Addendum 79: Regulation No. 80

Amendment 1

01 series of amendments - Date of entry into force: 8 February 1998

**UNIFORM PROVISIONS CONCERNING THE APPROVAL OF SEATS OF LARGE PASSENGER VEHICLES
AND OF THESE VEHICLES WITH REGARD TO THE STRENGTH OF THE SEATS AND THEIR
ANCHORAGES**

Appendix 5 - Figure 1

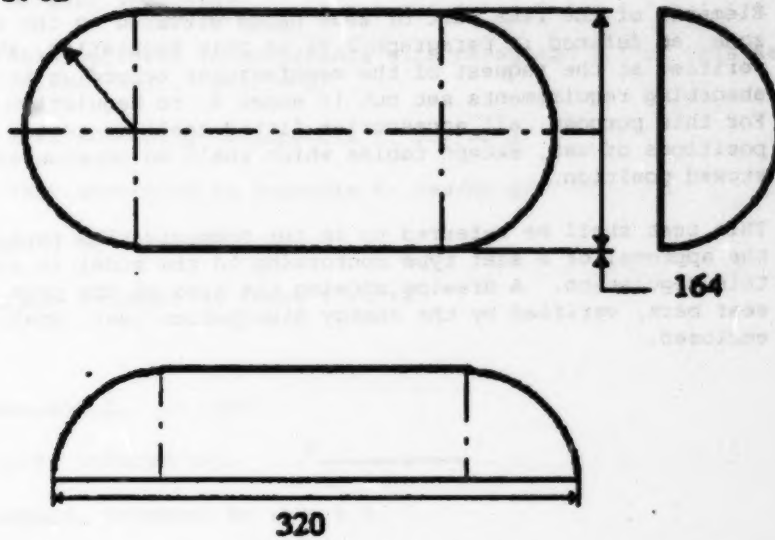
- 2.1.1. This consists of cylindrical surfaces with a radius of curvature equal to 82 ± 3 mm and a width:
 - 2.1.1.1. at least equal to the width of the seat-back of each seating position of the seat to be tested for the upper form,
 - 2.1.1.2. equal to $320 -0/+10$ mm for the lower form as shown in Figure 1 of this appendix.
- 2.1.2. The surface resting against the parts of the seat shall be made of a material the hardness of which is not less than 80 Shore A.
- 2.1.3. Each cylindrical surface shall be equipped with at least one force transducer able to measure the forces applied in the direction defined in paragraph 2.2.1.1.
